UNITED STATES PATENT AND TRADEMARK OFFICE

APPLICATION NO.	FILING DATE	FIRST NAMED INVENTOR	ATTORNEY DOCKET NO.	CONFIRMATION NO.
10/634,118	08/04/2003	D. Keith Miller	4847-04A	5751
4678	7590	08/10/2006	EXAMINER	
MACCORD MASON PLLC 300 N. GREENE STREET, SUITE 1600 P. O. BOX 2974 GREENSBORO, NC 27402			LUGO, CARLOS	
			ART UNIT	PAPER NUMBER
			3676

Office Action Summary	Application No. 10/634,118	Applicant(s) MILLER ET AL.	
	Examiner Carlos Lugo	Art Unit 3676

DETAILED ACTION

Attachment #1

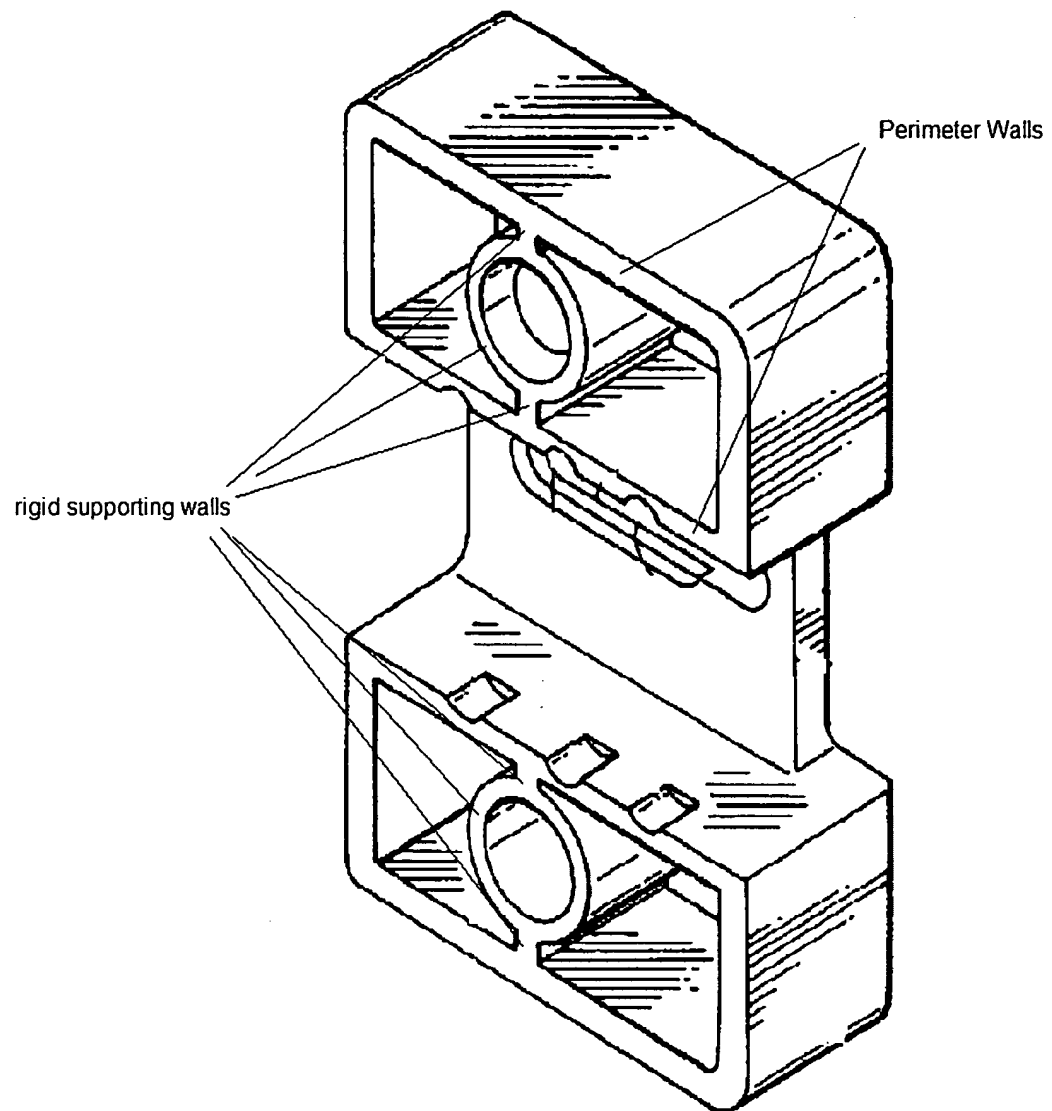
Diginosa teaches that it is well known in the art to have supporting walls that extends from one perimeter wall to another perimeter wall and that engage a surface of a window sash so as to impart strength to the housing (see attachment #1).
